Operator Quality Production Corp.
 Well Maljamar 'A' State #1
 Unit B Section 36 Township 17 Range 31
 API # 30-015-10400

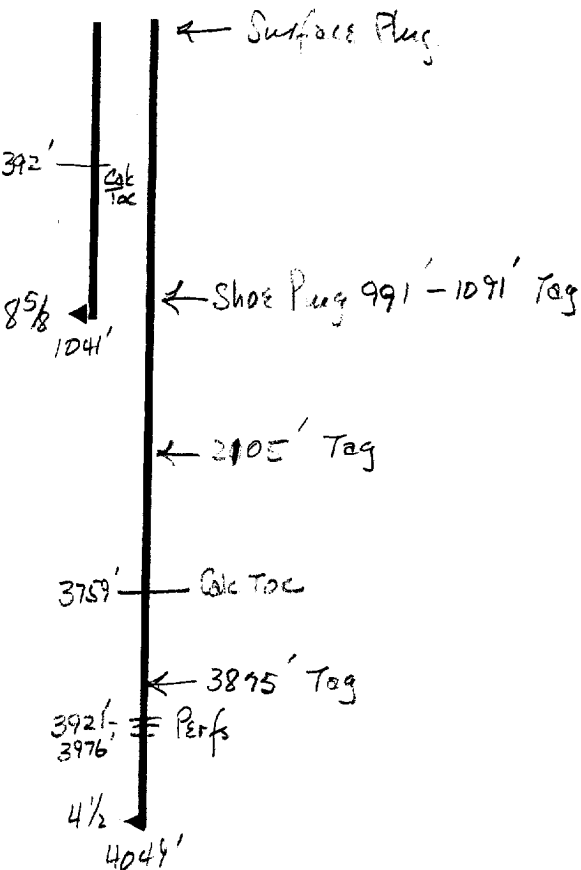
- * Contact OCD 24 hrs. prior to any work done.
- * Salt gel mud consisting of 10# brine with 25# of gel per barrel must be placed between each plug.
- * Install dry hole marker as per Rule 202.B.2
- * Plugs are to be set from point indicated up.
- * Plugs must not be less than 100' or 25 Sacks of cement, whichever is greater, unless specifically indicated.
- * Shoe and stub plugs will be 50' above and below shoe or stub and tagged.
- * Surface plug will be from 0' - 60'
- * Where plugs are required, cement must be placed inside and outside of all casing string(s) in the correct footage or sacks required, if no cement exists.
- * Plugs to be tagged will be indicated.
